# Inlet Elbow Cracks - Vertical Back-of-Cab Diesel Particulate Filter (DPF)

M-252-003

(May 2008)

**Inboard and Outboard Stanchions**

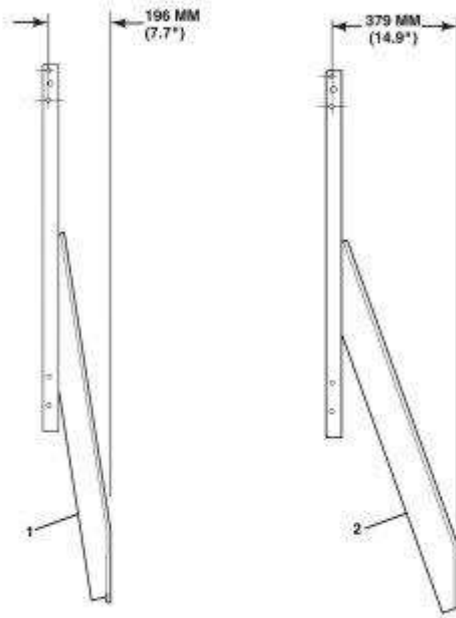
*Note: The part number for the replacement DPF inlet elbow depends upon the exhaust system mounting arrangement (inboard- or outboard-mounted) and finish (standard or bright). The difference between the two mounting arrangements is the tilt of the stanchion bracket. Refer to the following illustration for the difference between the inboard or outboard stanchions.*

### Drilling Location for Exhaust Pipe Mounting Bracket

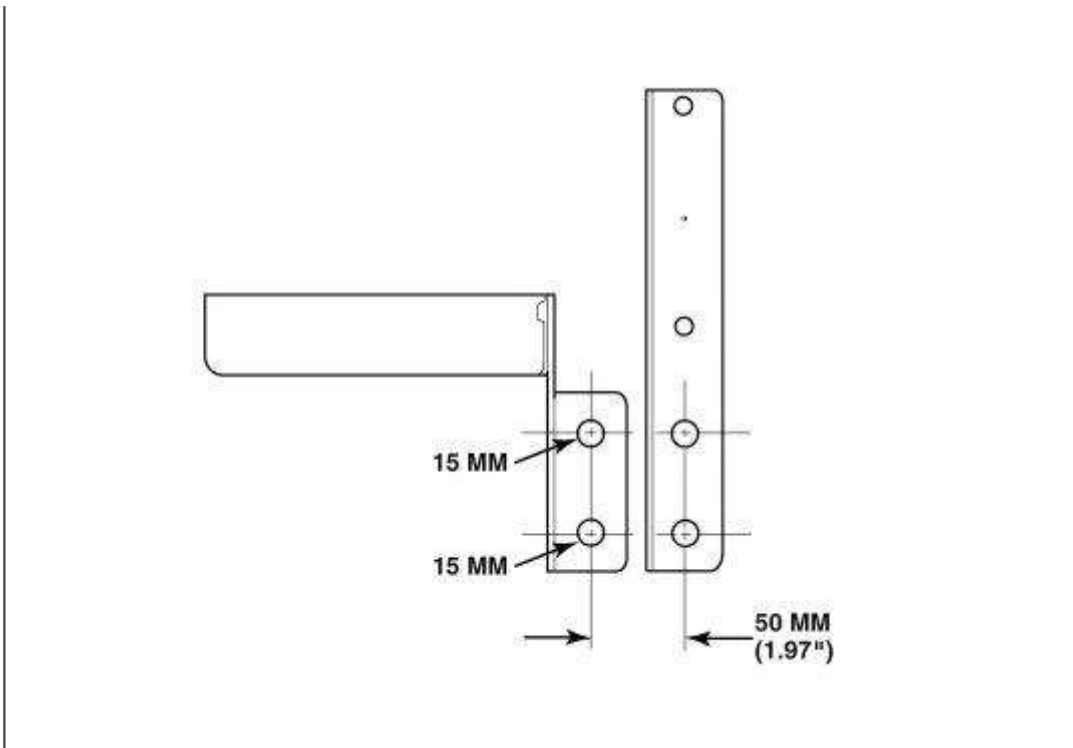
Changing to the dual flex exhaust pipe arrangement requires an additional support bracket (part No. 21144215, item 4 in figure 1). Installation of this bracket requires that two 15 mm diameter holes be drilled in the frame rail. Position the new bracket to the rear of the existing bracket with the vertical centerline of the mounting holes located 50 mm (1.97") from the vertical centerline of the holes in the existing bracket, and the horizontal centerlines on the same plane. Mark and drill the two 15 mm diameter holes in the frame rail, and use two 14 mm Huck-Spin® pins (part No. 3187721) and two collars (part No. 3187719) to secure the bracket to the frame rail.

*Note: Installation of the intermediate exhaust pipe mounting bracket involves removal and reinstallation of the fuel tank. The mounting bracket must be mounted with the leg on which the exhaust pipe is mounted parallel to the frame rail.*
